BACKGROUND:

PROBLEM:

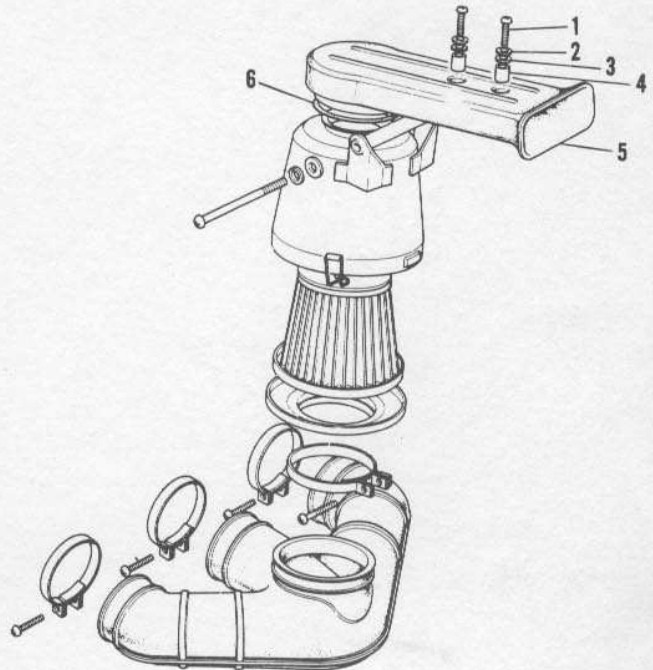
A silencer has been installed on top of the air cleaner housing of the H1B (disc-brake model). The resulting decrease in overall vehicle noise is gained by damping out the "moaning" sound from the engine air intake system. This air horn must be used on all 1972 H1's sold in California to meet the State's lower standards for motorcycle noise levels, which takes effect in January 1972.

Because of a production error, some of the initial shipment of H1B's were not equipped with the silencer at the factory. These motorcycles must have the silencer installed before sale in California. To promote better relations with the non-motorcycling public, the silencer should be installed on all H1B's in the field. The required parts are shown below.

Don't use overlong screws and don't leave out any washers or the screws will protrude from the bottom, damaging the battery.

Install the air cleaner silencer on any H1B which was not originally equipped with the silencer using job code X007 (0.1 hr.)
